County of Santa Clara

FILE NUMBER: PLN20-134
SUBJECT: Building Site Approval, Design Review (Tier II), and Grading Approval Applications
SITE LOCATION: 3412 Fowler Road, San Jose (APN: 660-33-009)
DATE RECEIVED: April 11, 2023

Your application for Building Site Approval, Design Review (Tier II), and Grading Approval was received on the above date and is deemed **incomplete**. For the application processing to resume, you must resolve the following issues and submit the information listed below.

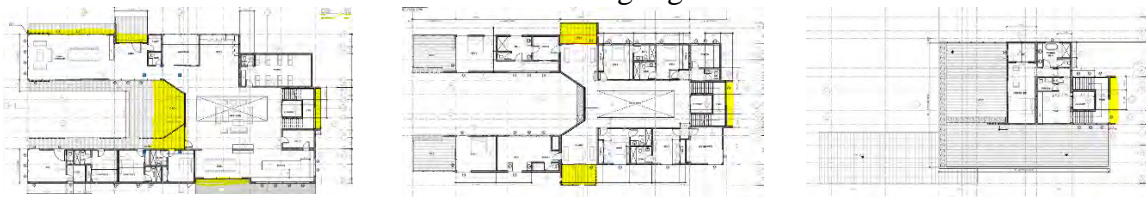
2. Legality verification of APN 660-33-009 is NOT established yet with the supplemental deeds submitted on 4/11/2023. Please submit recorded deed prior to June 25, 1969, with the same configuration with the current deed. This information is necessary to ensure that the lot in its current configuration was conveyed before 1969 and thereafter.

For future deeds resubmittal, please ensure the documents are complete with no missing pages, and the deeds must be clearly readable. Please also provide the book and page number of the document if that information was not shown on the document itself. Please mark / note on the deed if it involved more than one parcel. You may consider of consulting a surveyor for the interpretation of the legal descriptions.

Please see additional deeds
